**No. 93-21**

## A. POSSIBLE WATER LEAKAGE PAST TRANSOM MOUNTING STUDS ON ALPHA AND BRAVO TRANSOM ASSEMBLIES.

**Figure -1**

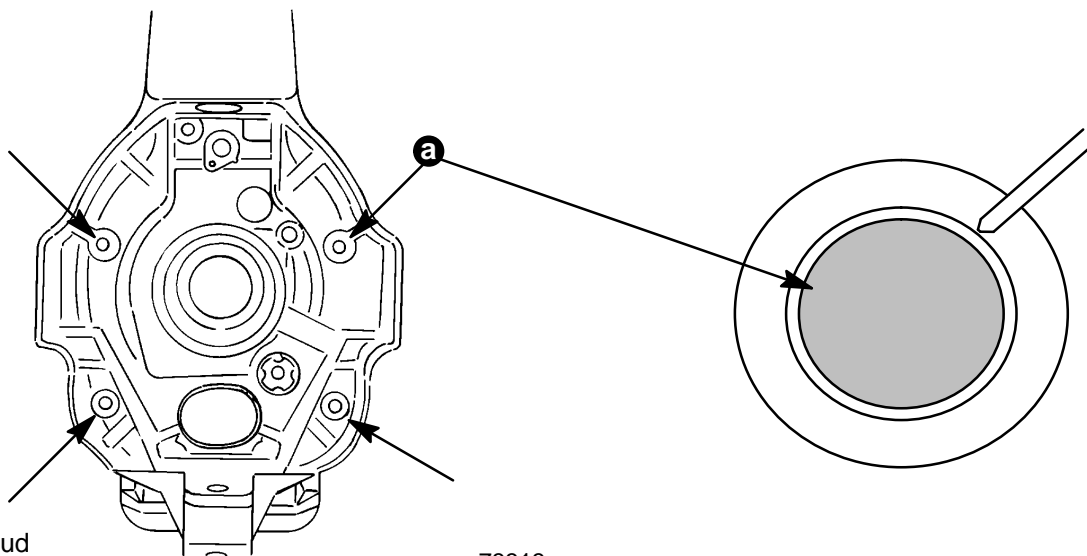
Some Alpha and Bravo transom assemblies may have been built with insufficient sealant on the threads of one or more of the transom mounting studs. Studs with insufficient sealant on the threads could allow a small amount of water to weep past the threads and enter the boat over time.

Turn the drive as far to the starboard as possible and apply approximately two drops of sealant to the two exposed studs on the port side of the transom. Apply the sealant to the top of the threaded area so the sealant can wick around the circumference of the stud. (See figure 1.) Turn the drive to port and apply sealant to the two starboard studs.

Let the sealant cure for a minimum of three hours before putting the boat back into the water.

If the boat has been in the water for an extended time, clean the ends of the studs with Loctite N Primer obtained locally or through your normal parts distribution by ordering P/N 92-806497A1.
